# *Addendum*

| **Project Name** | Dexter Community Schools – Dexter High School New Field House |
| **Design Release No.** | Two (2) |
| **Addendum No.** | One (1) |

**M4.1A**

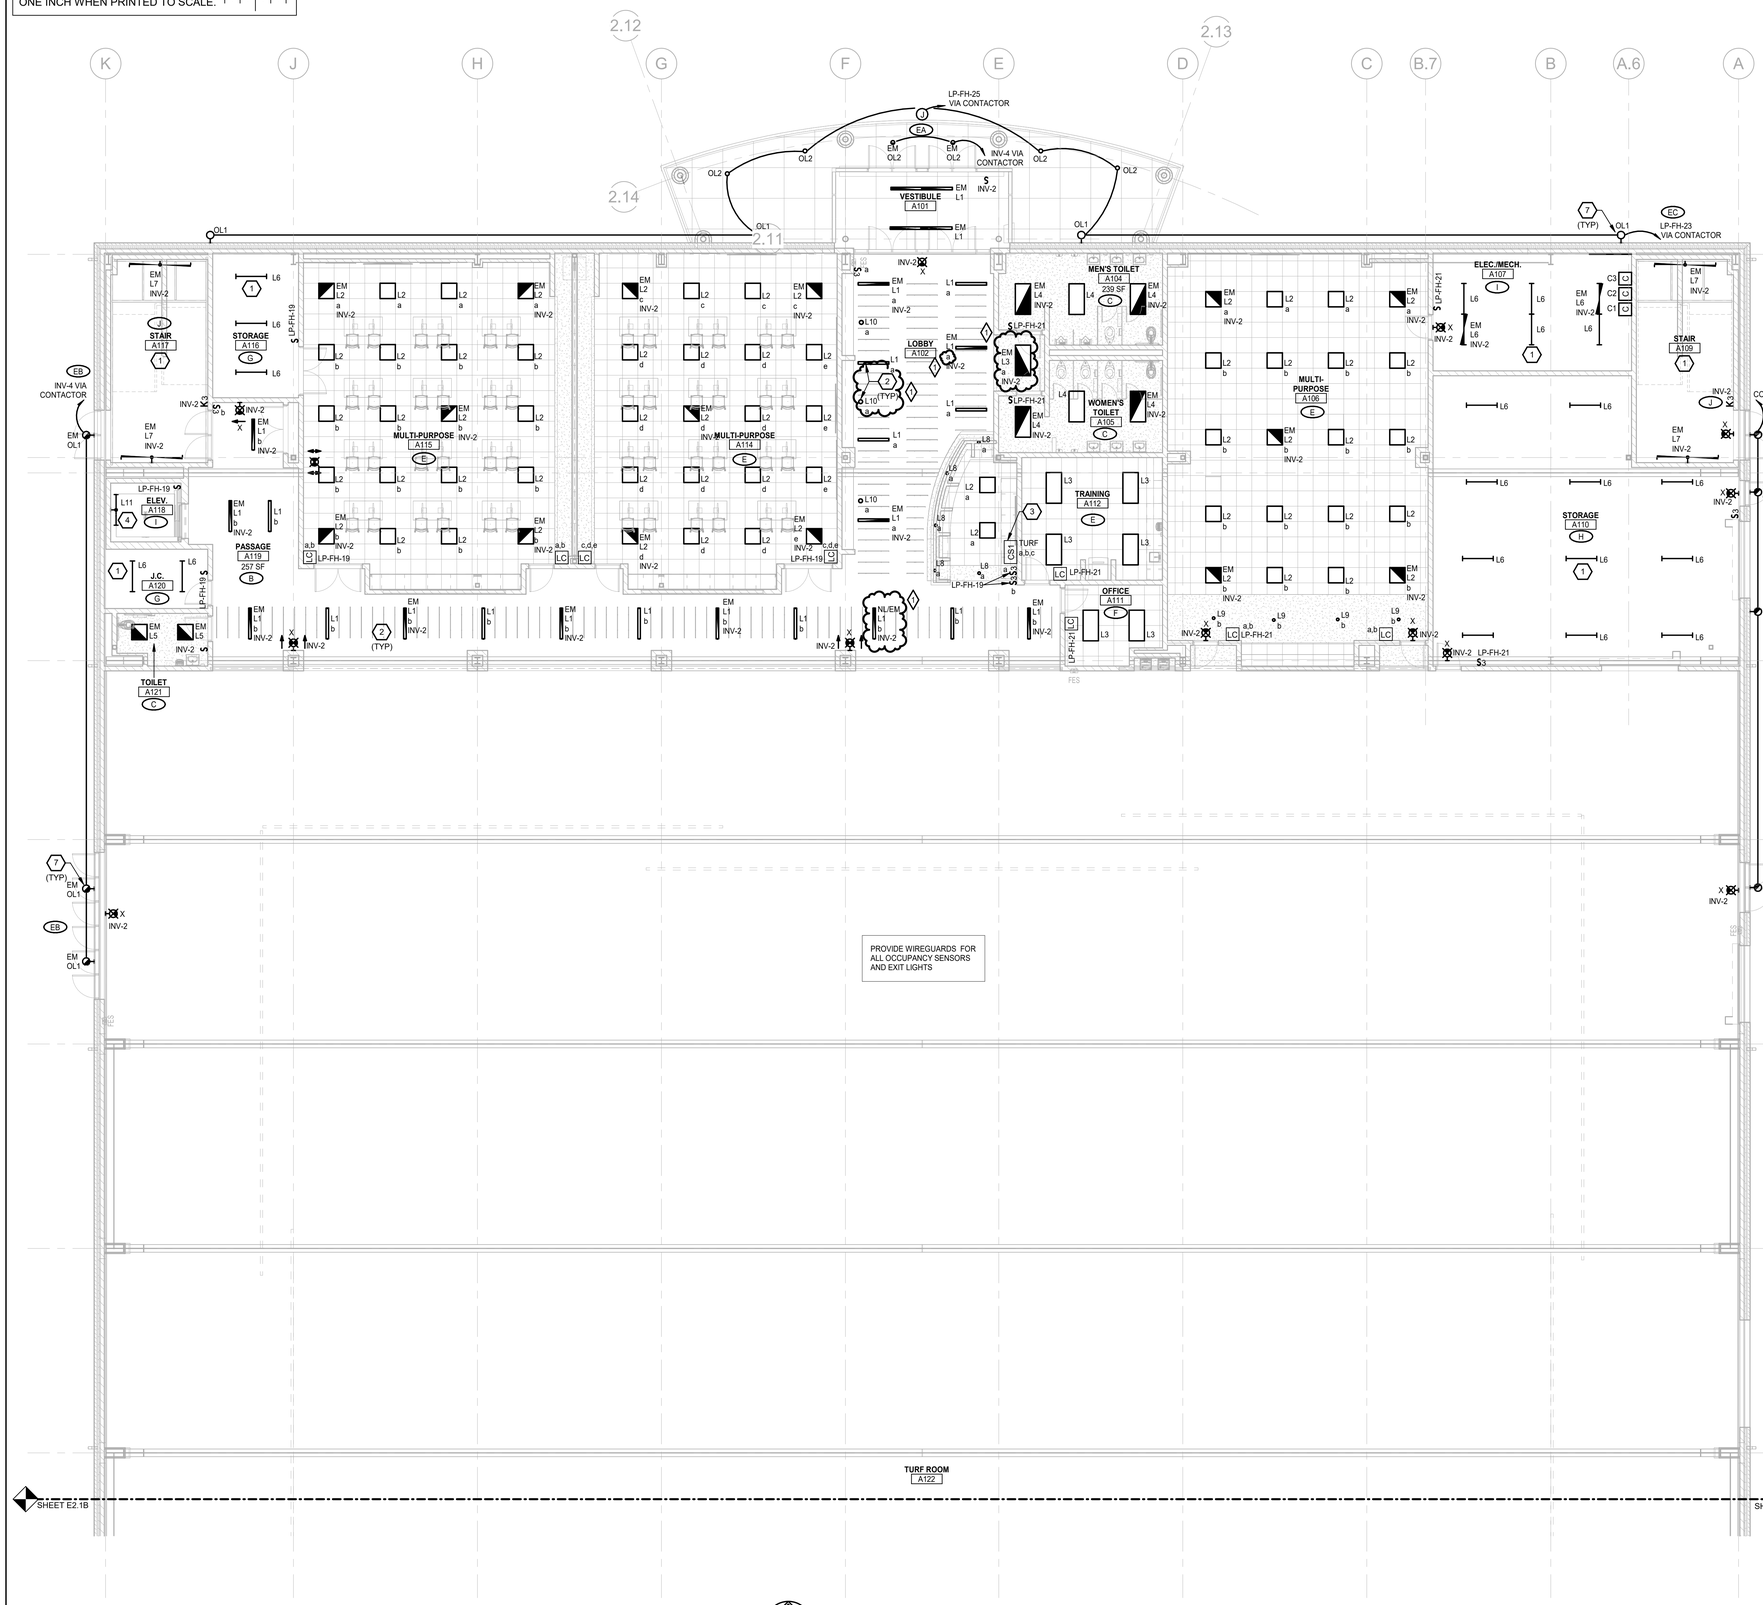
| MD-3 | Refer to Drawing No. M4.1A (reissued):<br>A. Shifted supply duct main location. |

## LIGHTING CONTROLLER DETAIL

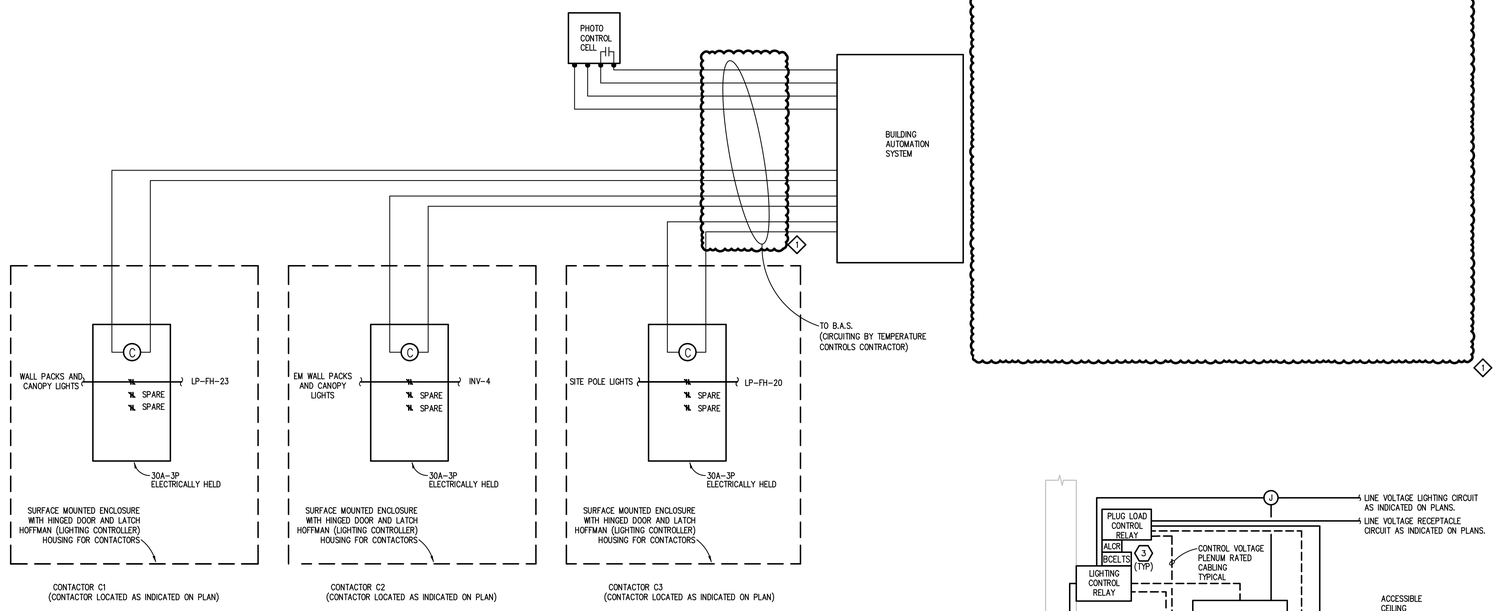
| ED-8 | Refer to Drawing No. E7.1 (reissued):<br>A. Removed telecommunication outlet detail as indicated.<br>B. Revised lighting controller detail as indicated. |

## GROUNDING SYSTEM DIAGRAM PRIMARY SERVICE EXTERIOR SERVICE ENTRANCE EQUIPMENT

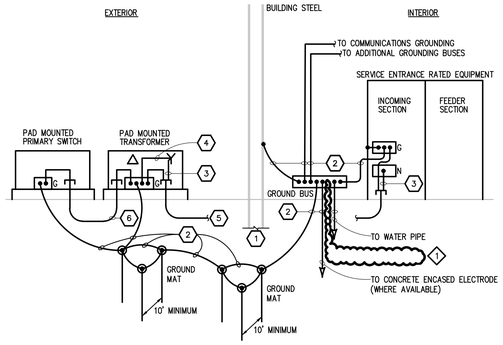
| ED-9 | Refer to Drawing No. E7.2 (reissued):<br>A. Revised grounding system diagram primary service detail as indicated.<br>B. Revised main telecommunications room grounding diagram detail as indicated. |

1 RACEWAY FIRST FLOOR-ZONE A
1/8" = 1'-0"

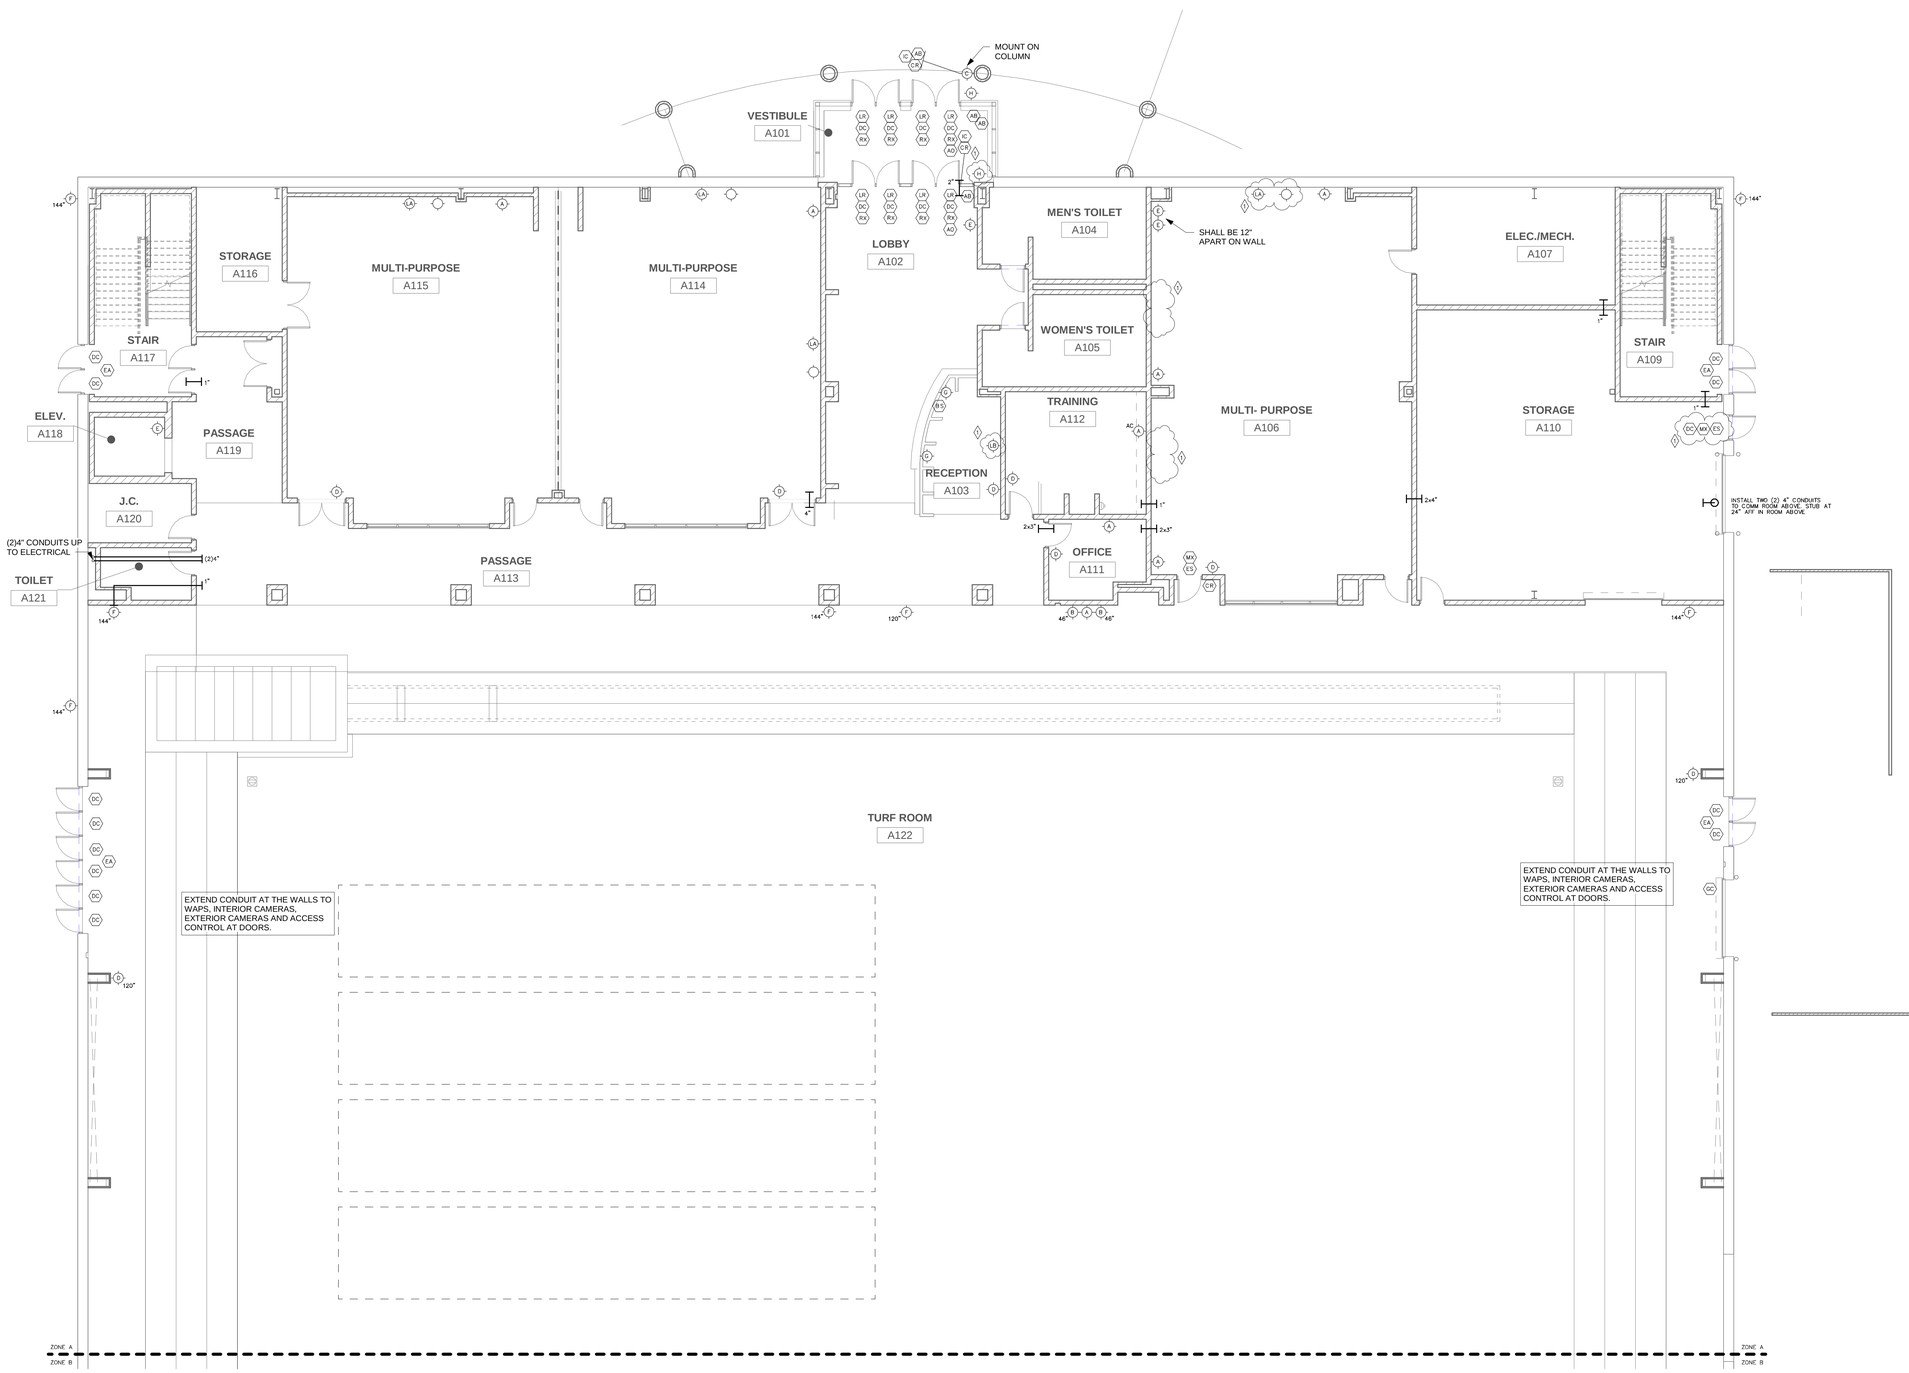
TD-13 Refer to Drawing No. TR201A (reissued):
A. Revised raceways as indicated.

1 RACEWAY FIRST FLOOR-ZONE B
1/8" = 1'-0"

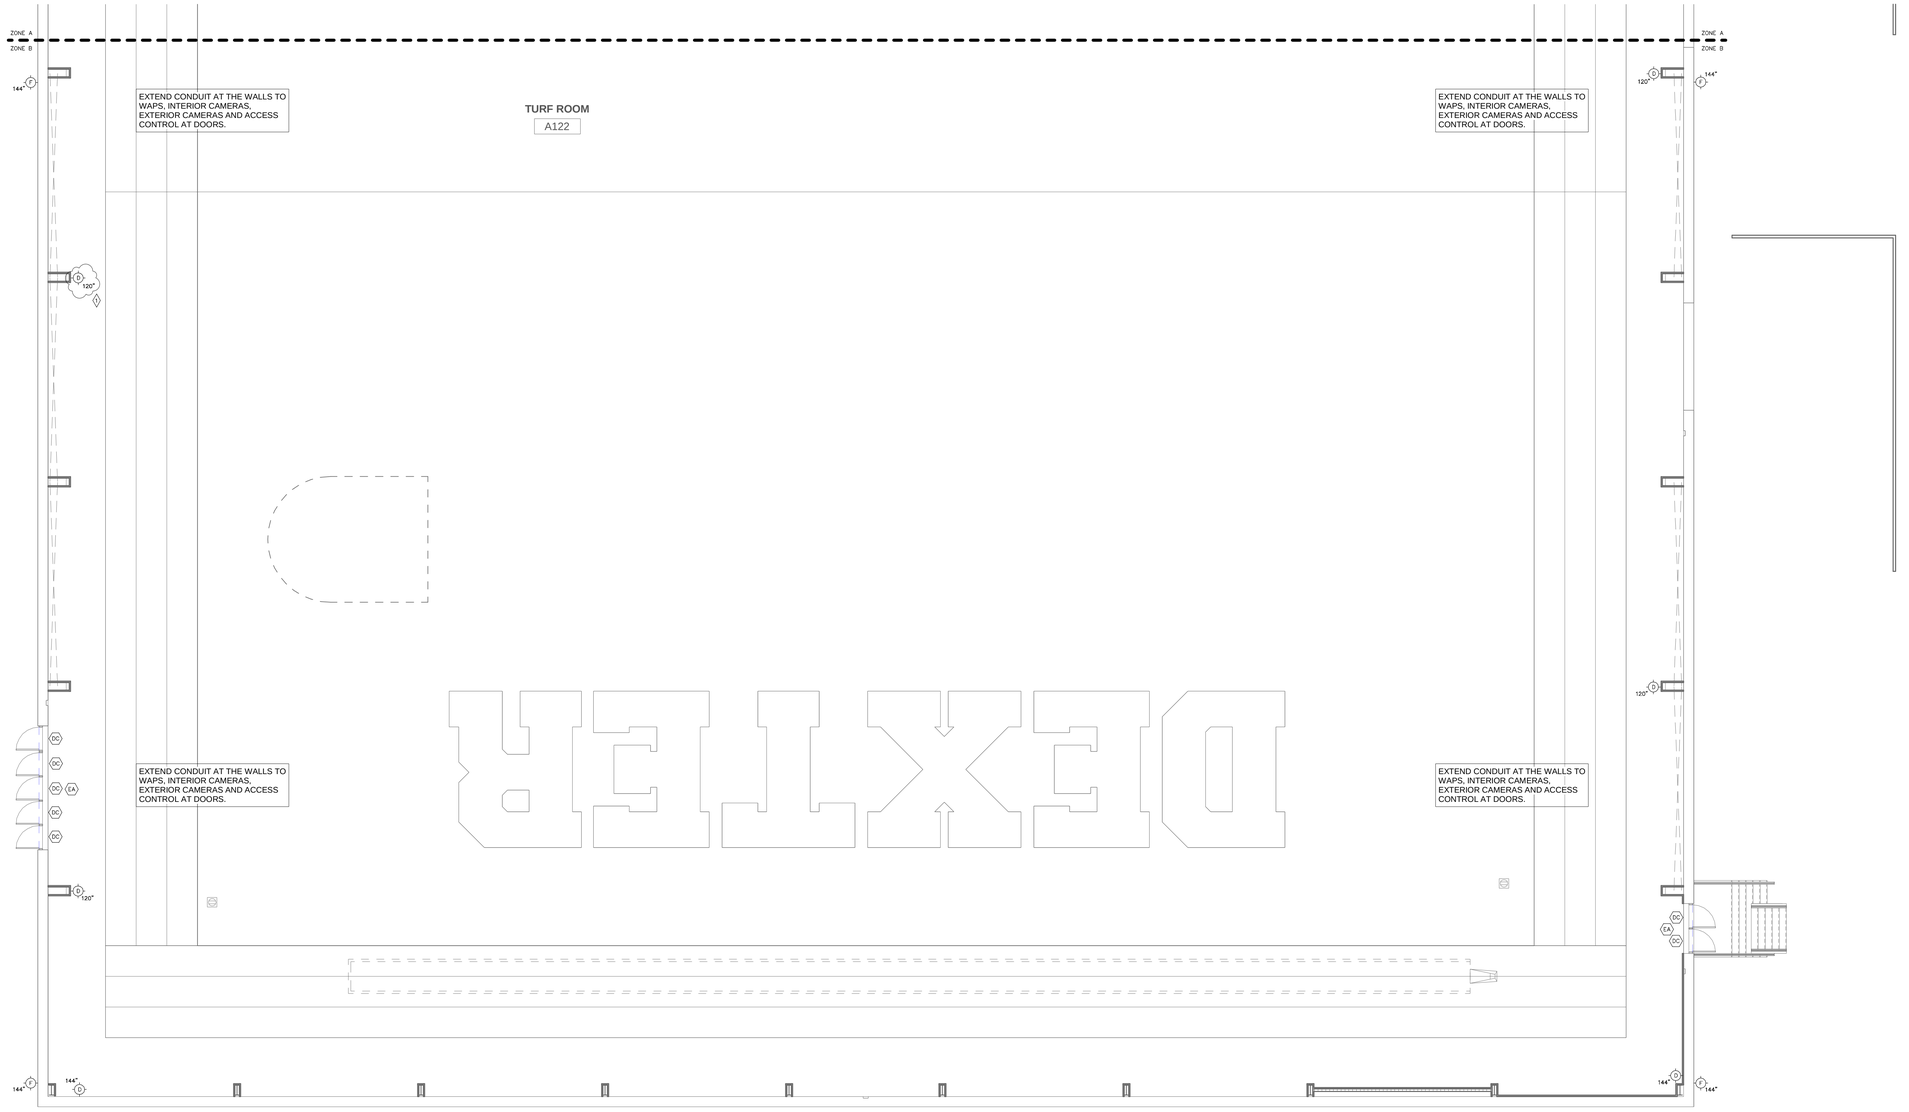
A. Revised raceways as indicated.

1 RACEWAY SECOND FLOOR-ZONE A
1/8" = 1'-0"

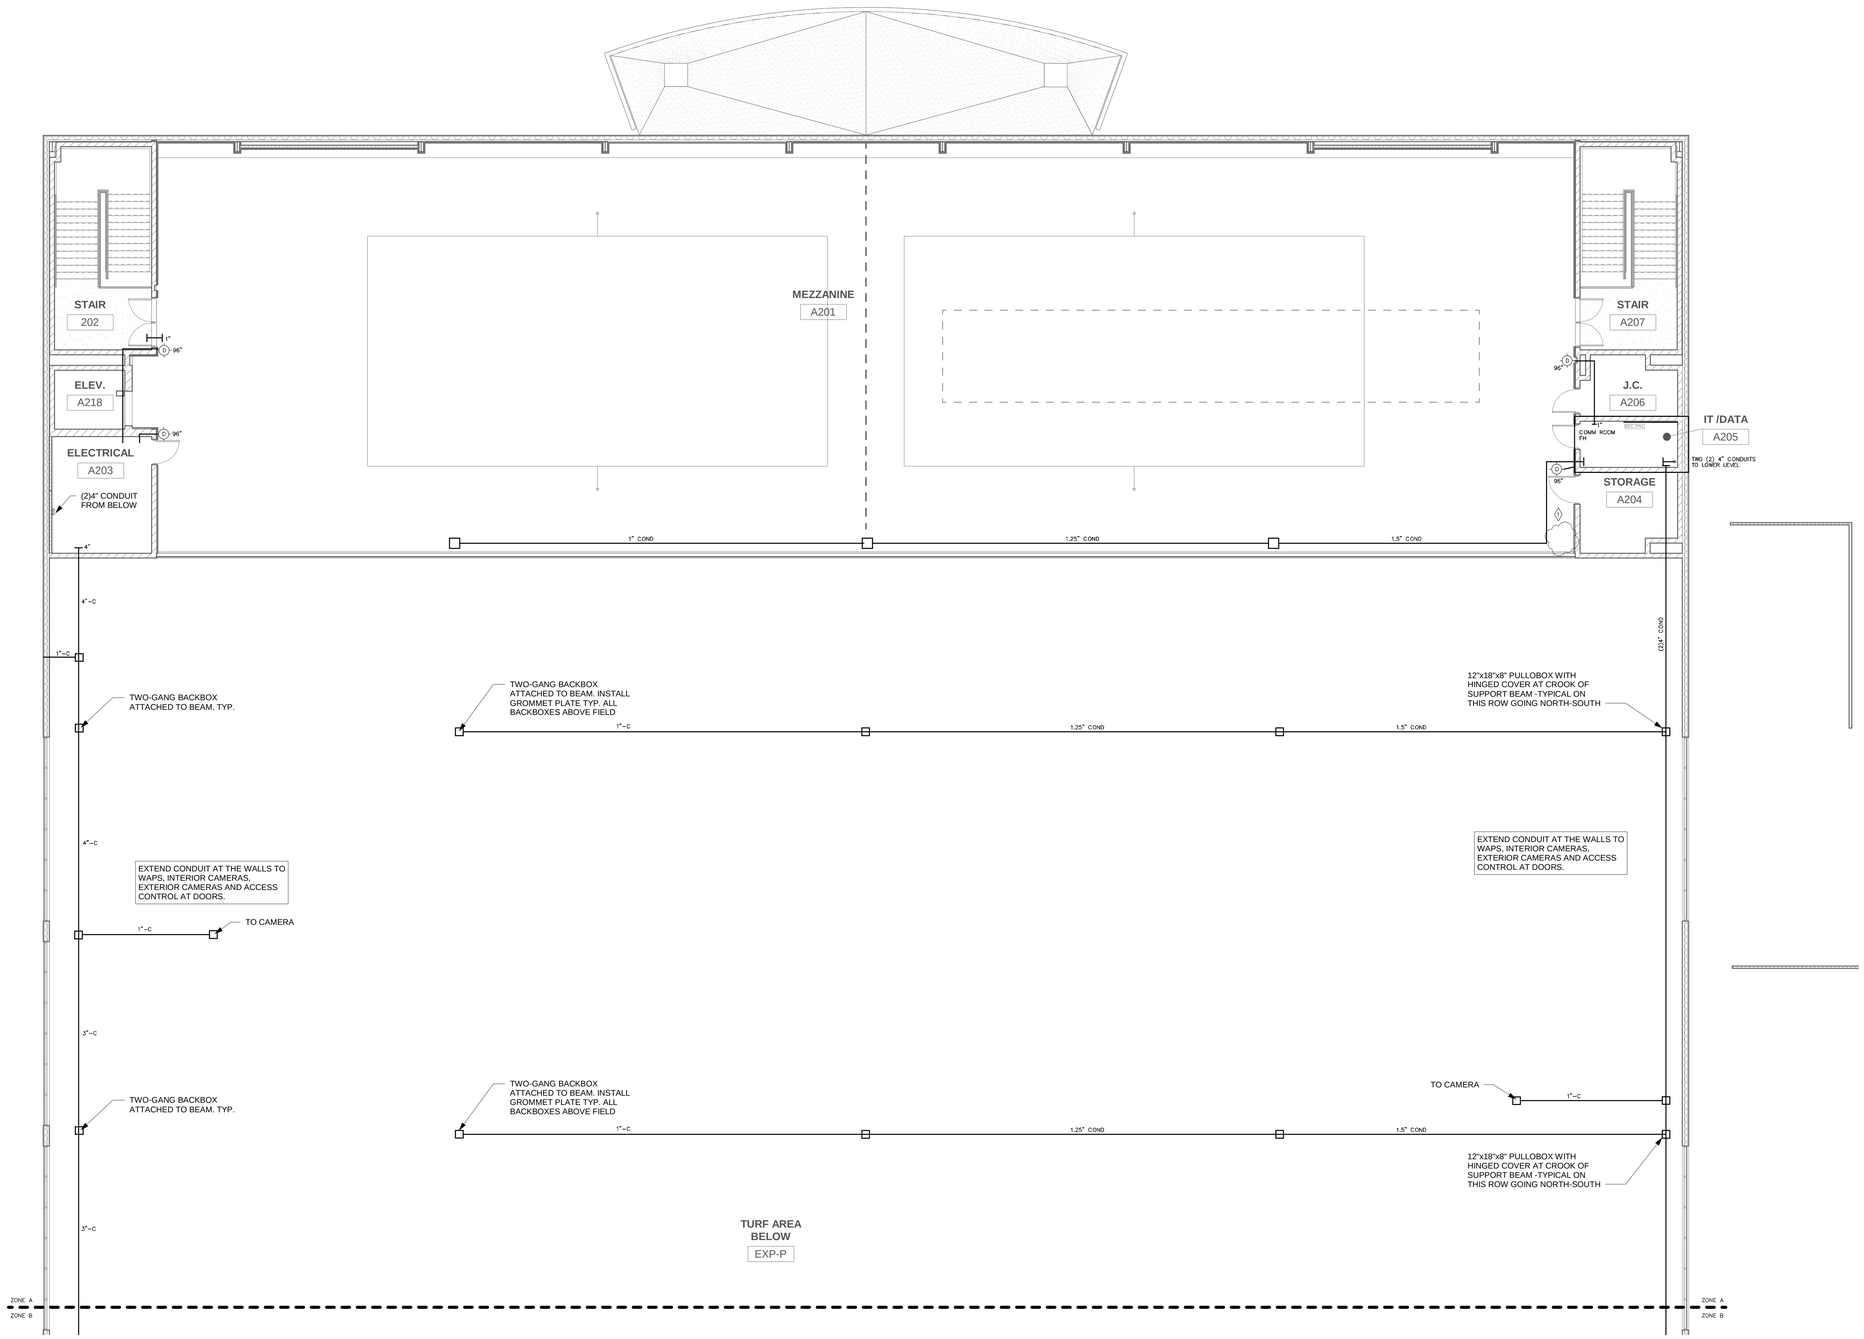
A. Revised raceways as indicated.
